CAMDEN COUNTY PLANNING BOARD
CHARLES J. DEPALMA COMPLEX
2311 EGG HARBOR ROAD
LINDENWOLD, NJ 08021

March 22, 2022

CAMDEN COUNTY PLANNING BOARD Land Development Review				Review List for Meeting March 22, 2022
<i>Applications for Approval</i>				
	PROJECT NAME	PROJECT NO.	MUNICIPALITY	DESCRIPTION
SP- 1	PSE&G Echelon Substation	SP-12-9-21	Cherry Hill	new sub station
SP- 2	Victory East	M-12-1-22/ SP-12-1-22	Cherry Hill	new ware house development
SP- 3	159 Lake View Drive	SP-13-2-21	Gibbsboro	conversion of existing building to mixed use
SP - 4	Boomerang 52, LLC	SP -36-5-21	Winslow	new ware house development
SP- 5	308 Haddonfield Rd.	SP-34-1-22	Voorhees	new deli

**CAMDEN COUNTY PLANNING BOARD
COUNTY ENGINEER'S REVIEW
OF SUBDIVISIONS AND
SITE DEVELOPMENT PLANS**

Project Name PSE&G Echelon Substation			Town Cherry Hill	
Block 519.11	Lot 2		camdencounty Making It Better, Together.	
0	62.5	125	250	Feet

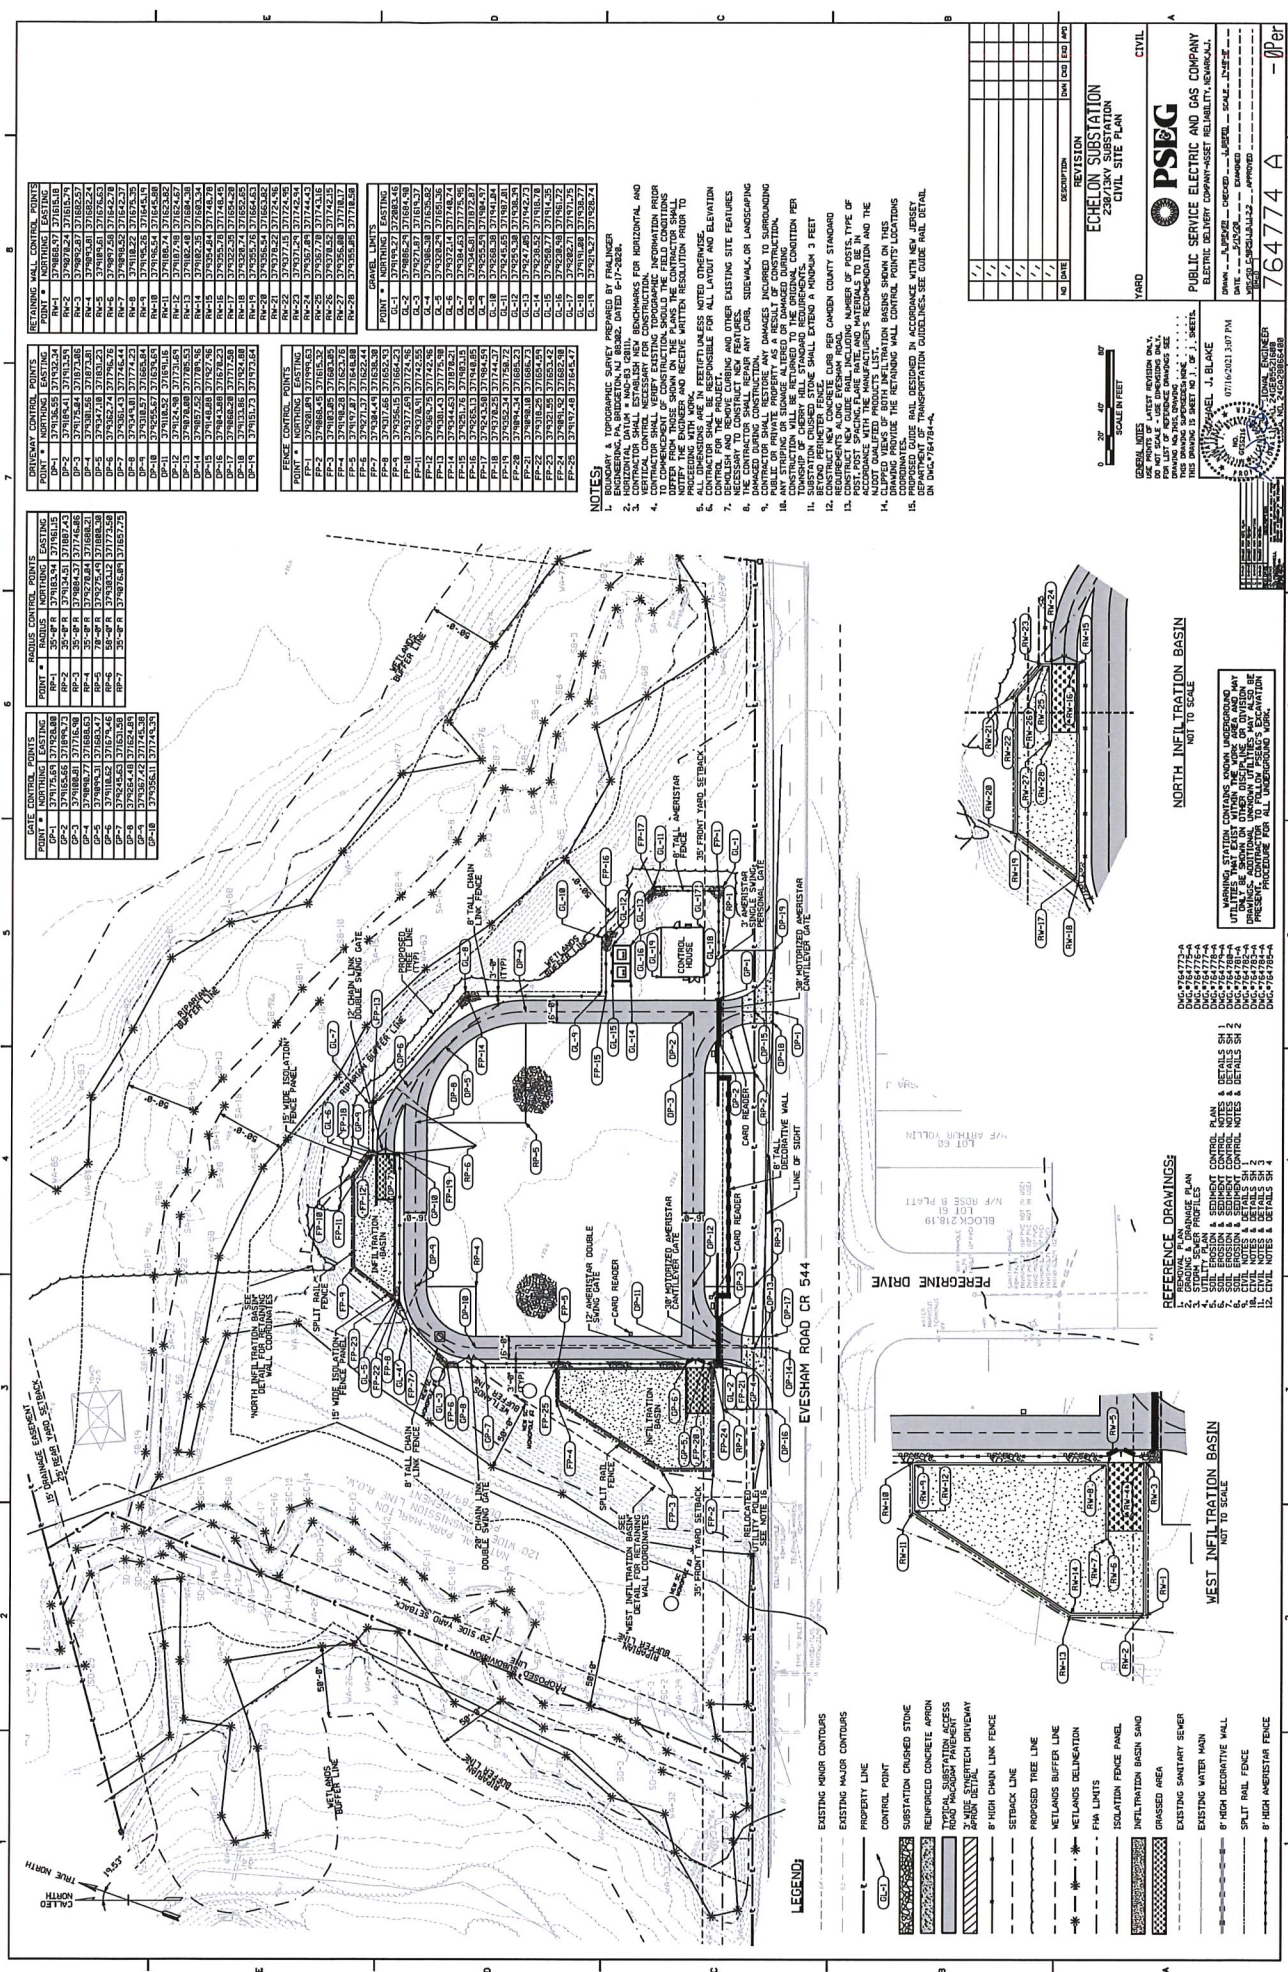
The Applicant is seeking approval to subdivide an 11-acre portion of Block 519.11 Lot 2 to construct a new unoccupied substation and expand their current network in Cherry Hill Township. Specific construction includes a control house, lighting mast monopoles, an A – Frame and security fencing.

The applicant proposed to construct guiderail within the County Right of Way.

Project Name Boomerang 52, LLC		
Block 3203	Lot 2	Town Winslow
 0 50 100 200 Feet		 N

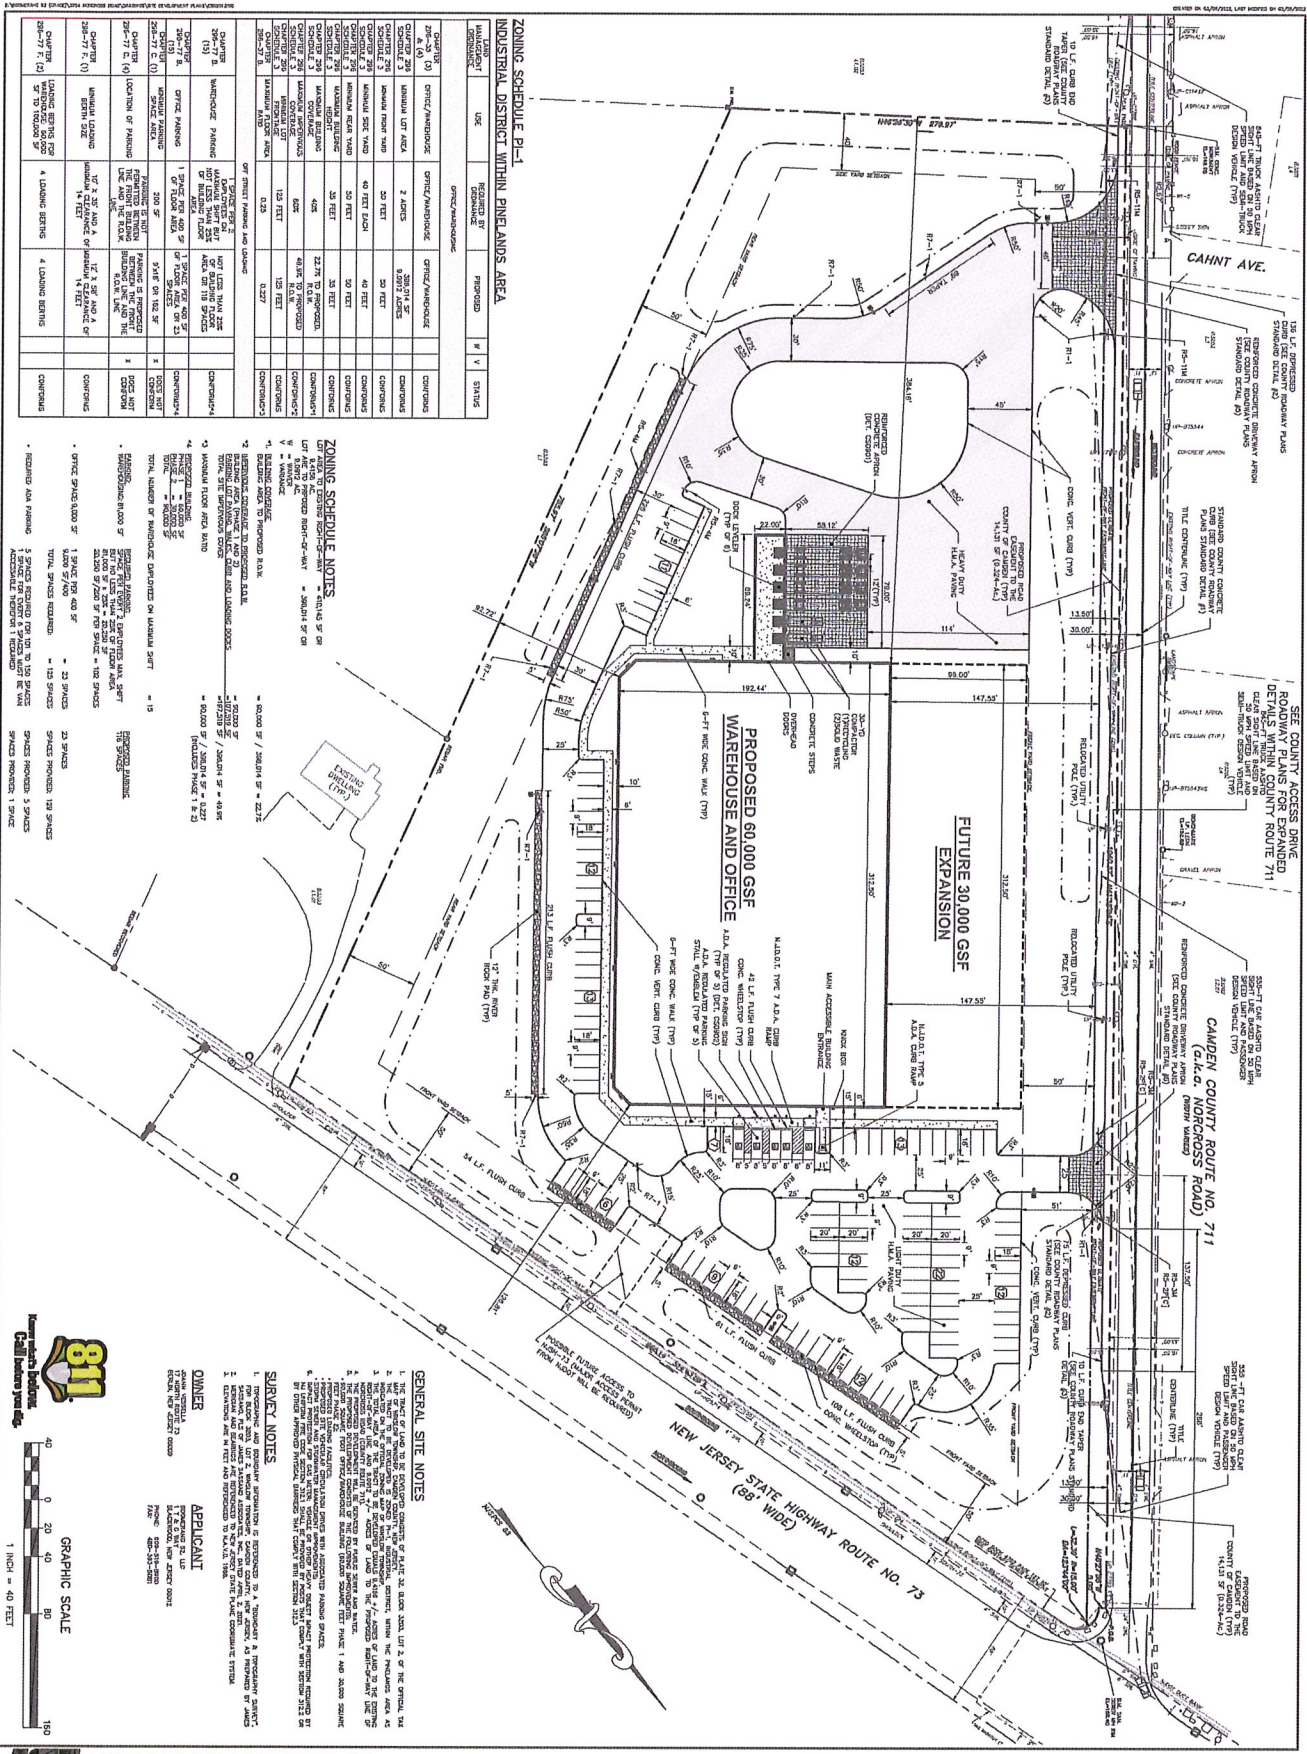
The applicant is seeking approval to construct a 90,000 SF warehouse building with office space, built in two phases, at the southwest corner of Norcross Road (CR #711) and NJ State Highway Route 73. The proposed development will have direct access from Norcross Road (CR #711) with a possible future connection to Route 73. Associated improvement includes two new full access driveways on County Rt. 711 Norcross Road. The proposed site will provide 129 on-site parking spaces. The site proposes 5 on-site infiltration systems with all drainage toward the southwest corner of the property, away from the County roadway.

County Planning and Engineering staff have worked extensively with the applicant on needed roadway charges that include curbing, stormwater management and widening roadway to ensure safe operations and site-specific ingress and egress turning movements.
